Model: Bellini – Punch Unit		Date: 17-Oct-00	No.: MA812001
Modified Article: Punch Drive Board		Prepared by: S. Hizen	
From: Technical Services Dept., GTS Division			
Reason for Modification:	<input type="checkbox"/> Parts catalog correction <input type="checkbox"/> To facilitate assembly <input type="checkbox"/> Part standardization	<input type="checkbox"/> Vendor change <input type="checkbox"/> To improve reliability <input checked="" type="checkbox"/> Other	<input type="checkbox"/> To meet standards ()

Model: Bellini – Punch Unit

No.: MA812001

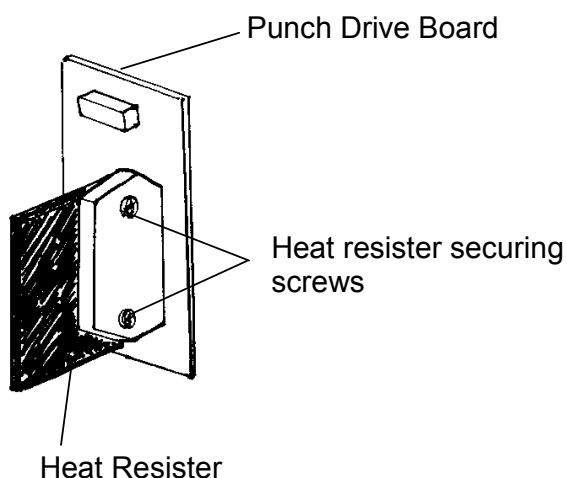
The heat resister securing screws of the Punch Drive Board have been locked in place with an adhesive.

Old part number	New part number	Description	Q'ty	Int	Page	Index	Note
A812-5120	A812-5150	Punch Drive Board	1-1	X/O	3	20

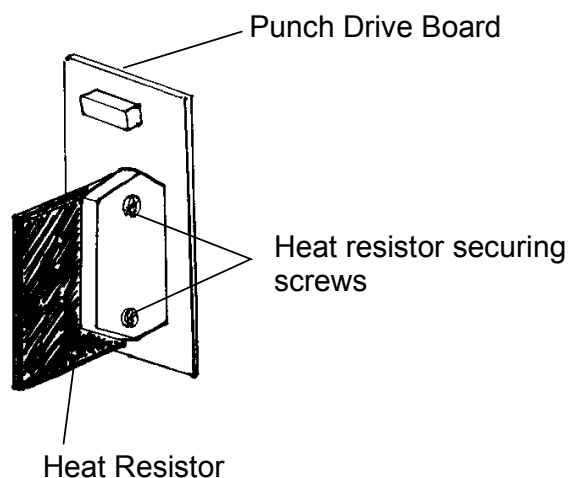
The Punch Unit has been modified to minimize the scattering of paper punch holes (chads).

Old part number	New part number	Description	Q'ty	Int	Page	Index	Note
A8127173	A8127183	Punch Unit – 3 Holes	1	X/O	3	12
